**CITY OF DOVER, DELAWARE
PLANNING COMMISSION
Monday, December 18, 2023 at 7:00 PM**

6. SB-23-03 Revised Stonebrook East Planned Neighborhood Design at McKee Road and W. Denneys Road - Public Hearing and Review of a Revised Subdivision Plan to increase the number of townhouses from 87 to 103 townhouses (increase of 16 townhouse units) and to decrease the number of garden apartment units from 168 to 138 garden apartment units (decrease of 30 units). This development known as Stonebrook East Planned Neighborhood Design (PND) proposes 241 dwelling units, recreational areas, open space, and stormwater management areas. The property is zoned RM-1 (Medium Density Residential Zone) and approved as a PND (Planned Neighborhood Design Option). The site is on the northeast corner of McKee Road and W. Denneys Road. Property Address: intersection of McKee Road and West Denneys Road. Property Owners: Hanae Harmony Properties and Stonebrook East 168 LLC. Tax Parcels: ED-05-057.03-01-01.00-000 to ED-05-057.03-01-92.00-000. Council District 1. *PND - Alternative Design Standards Requests: Townhouse Units – To permit a minimum lot width of 20 feet and reduction of minimum lot area. Garden Apartment

SHEET: C-001

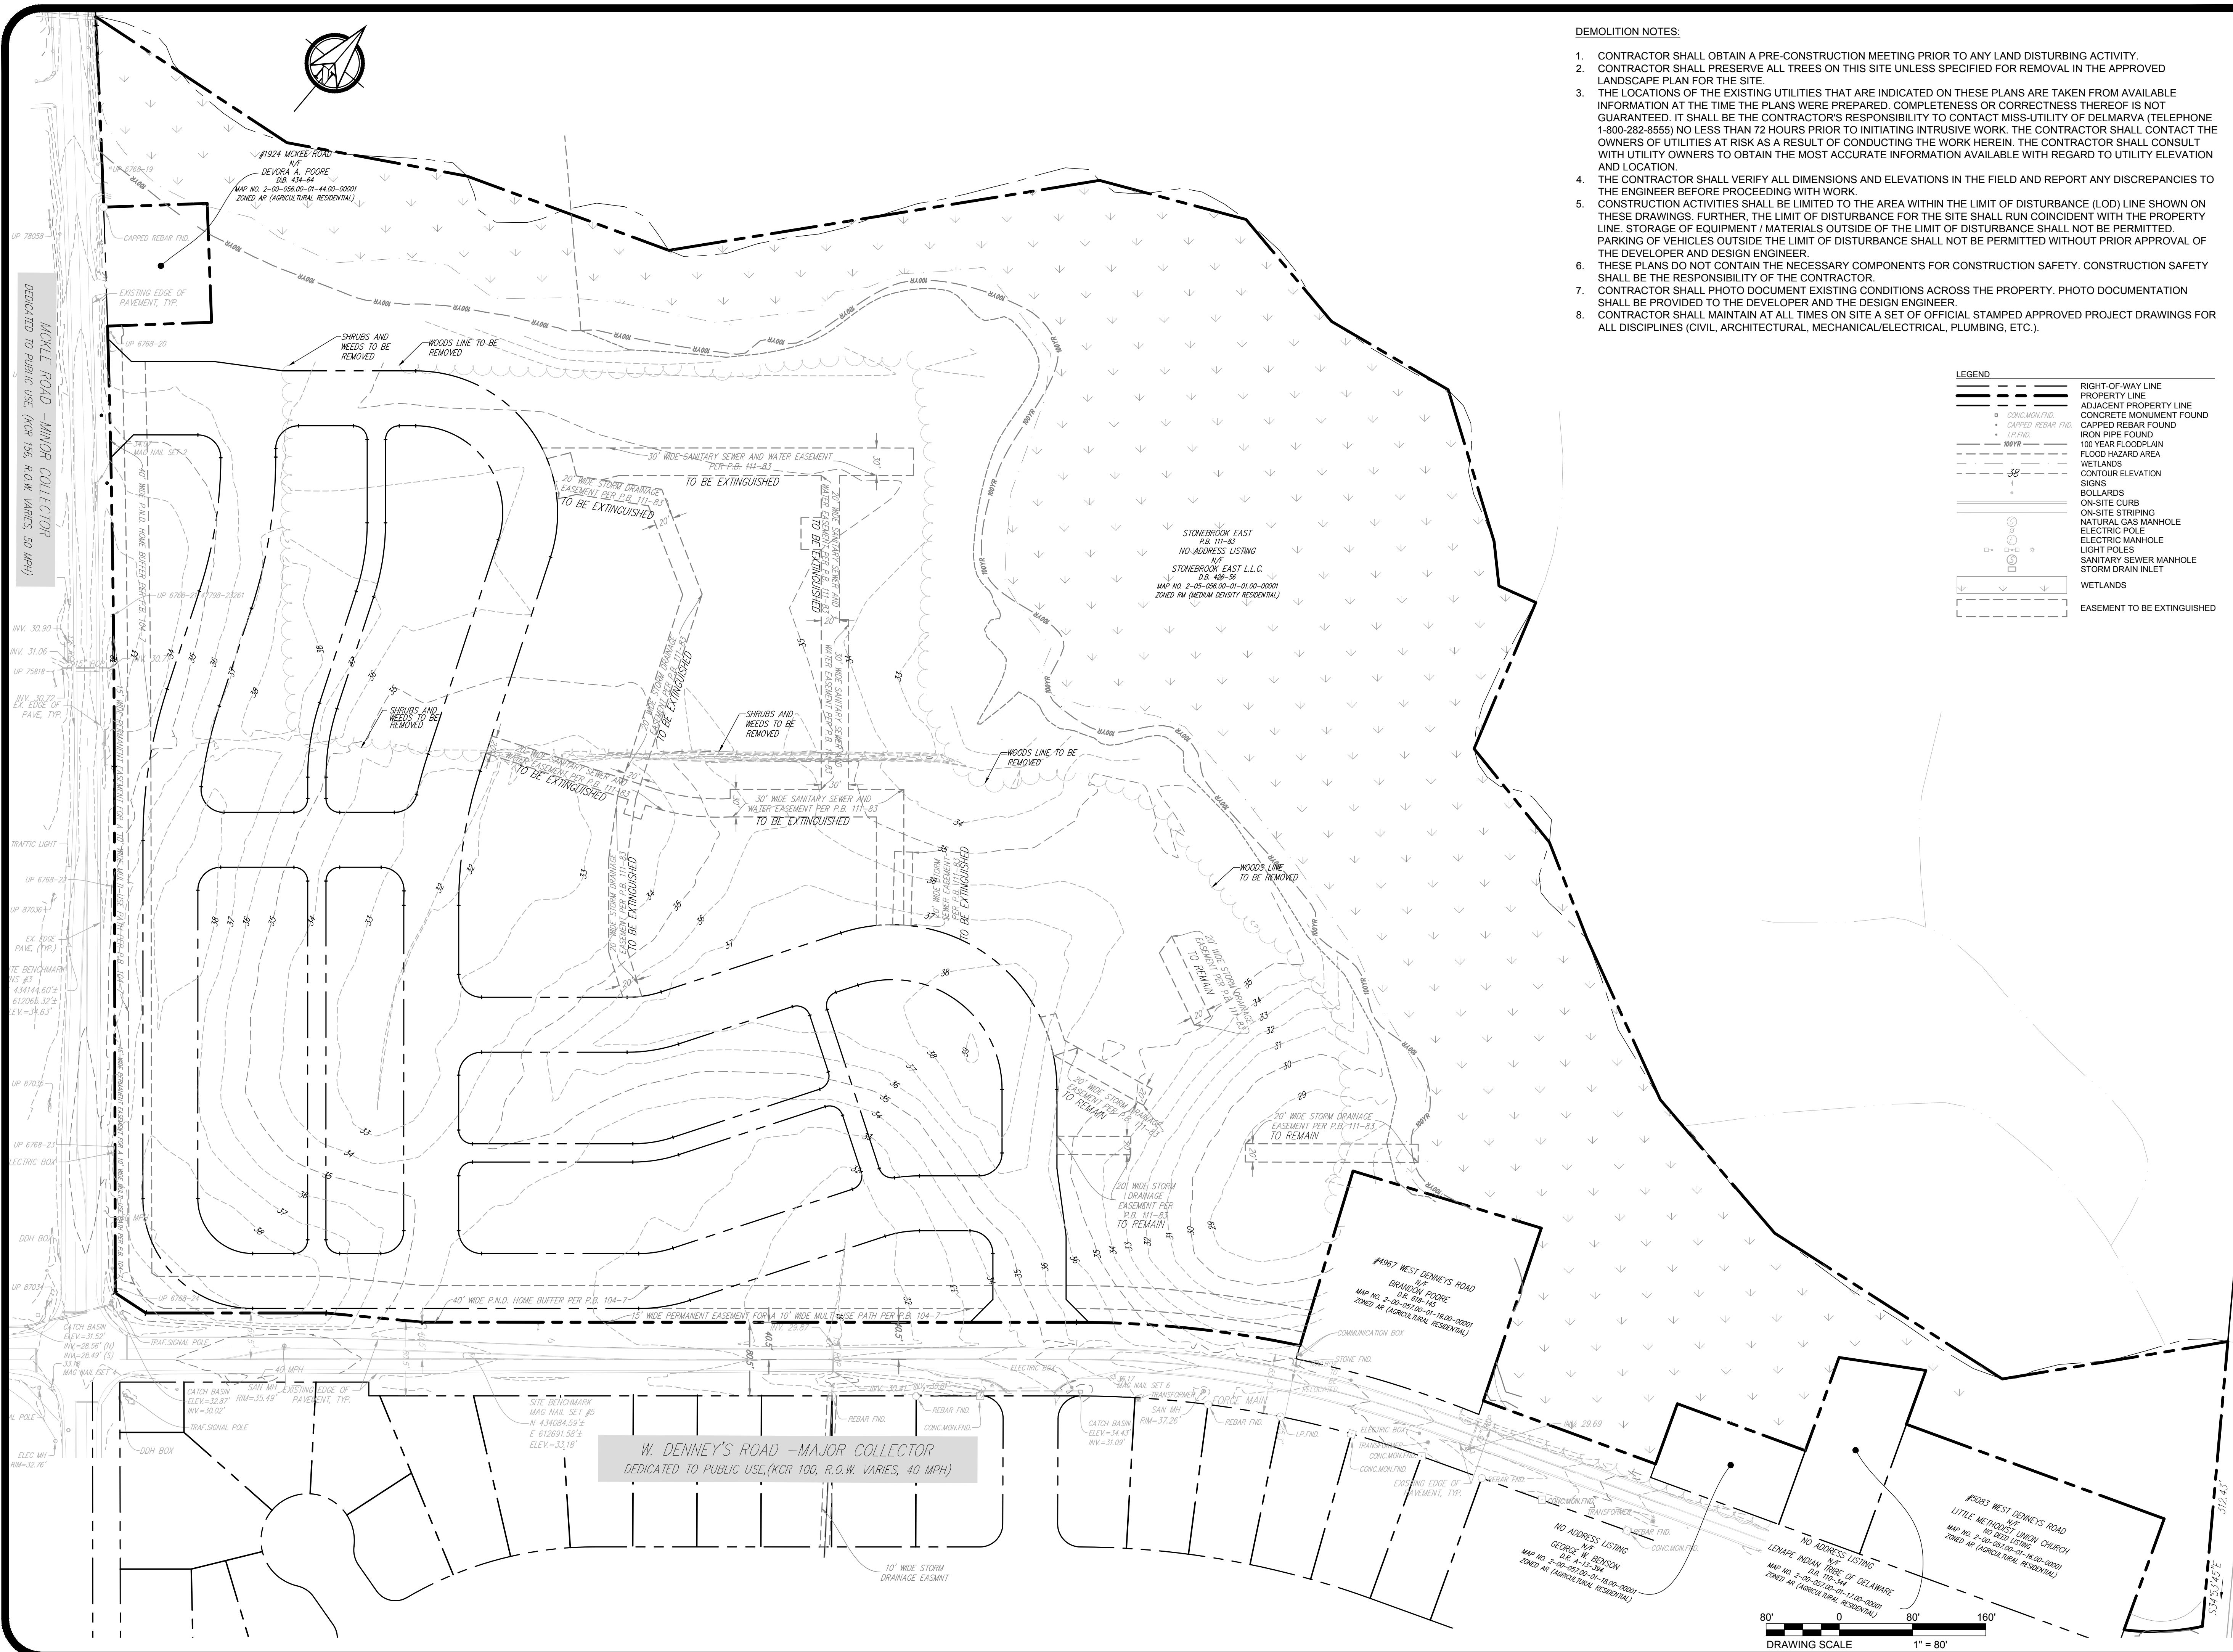
Please confirm that these are the only Alternative Bulk Standards being sought. Check the building spacings, lot coverage, and other setbacks. Check Site Data column on Sheet C-001.

DATE: NOVEMBER 03, 2023
SCALE: 1" = 80'
PROJECT NO. 13053.CA
SHEET: C-101

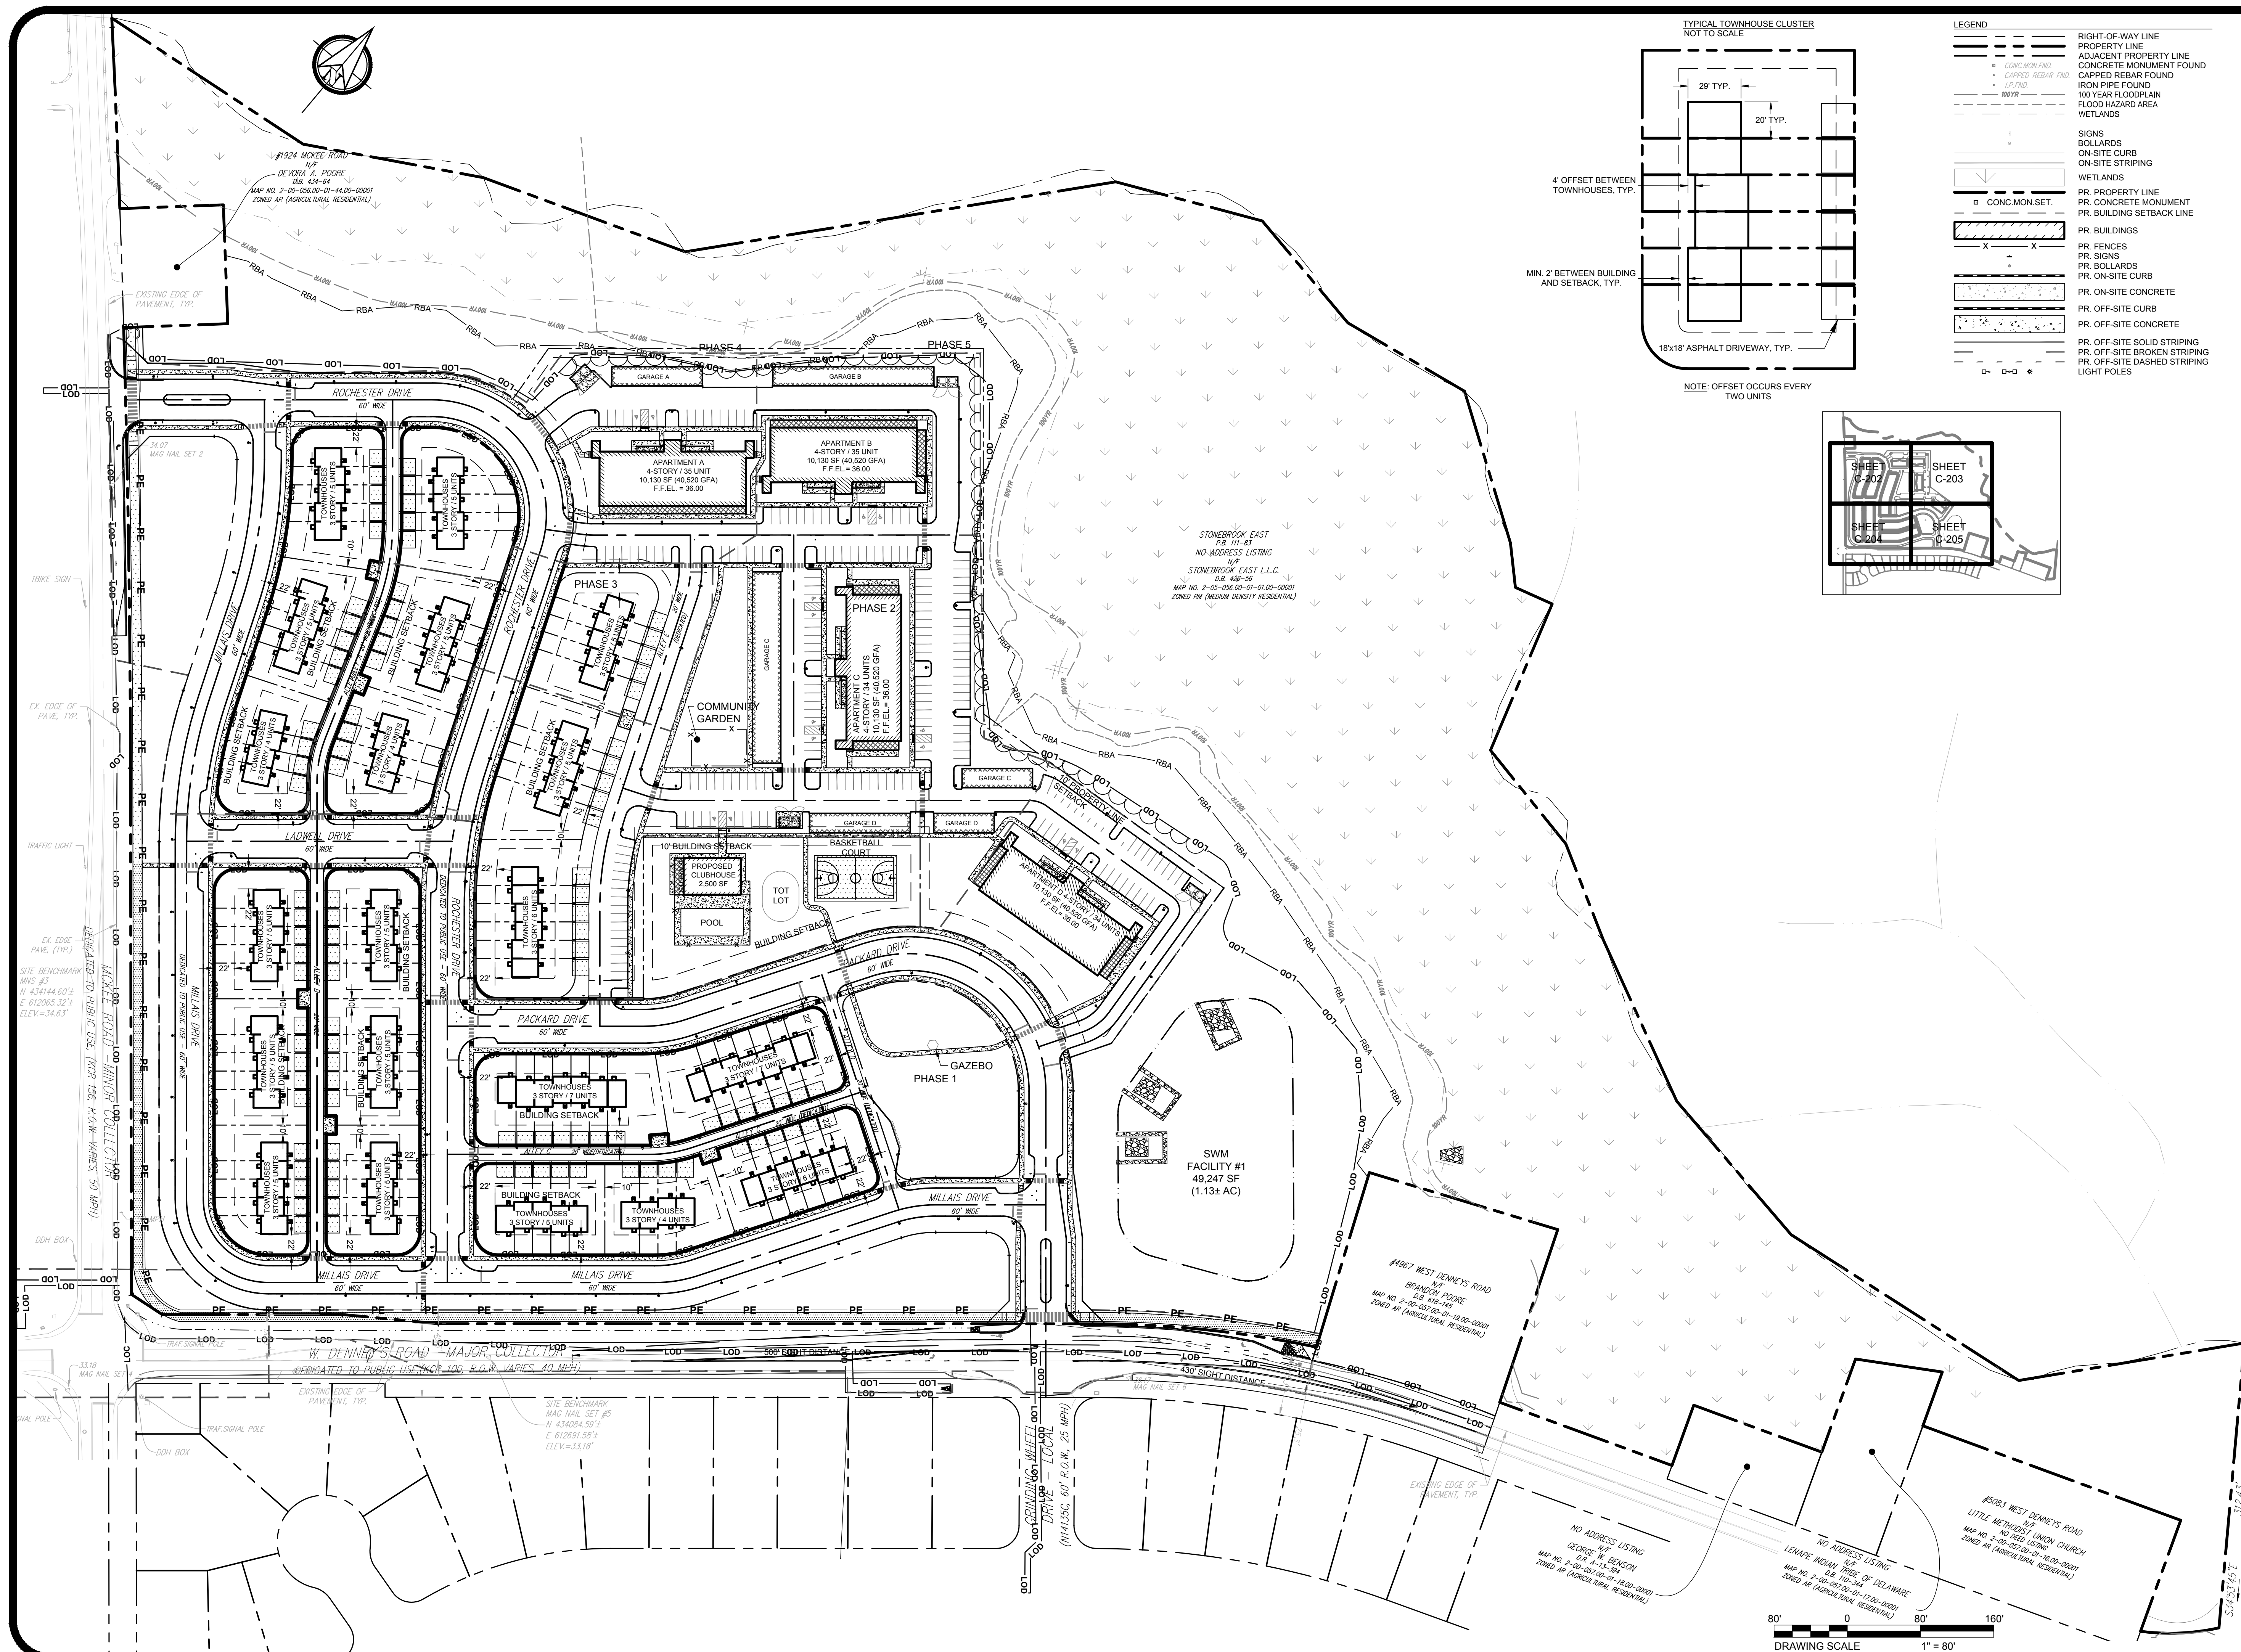
- h. Revise Note #21 as the entire site is not within Flood Zone X.
- 7) Sheet C-101 – Existing Conditions/Demolition Plan:
 - a. The 40' PND Buffer for homes can be removed as that is no longer a requirement of the Code.
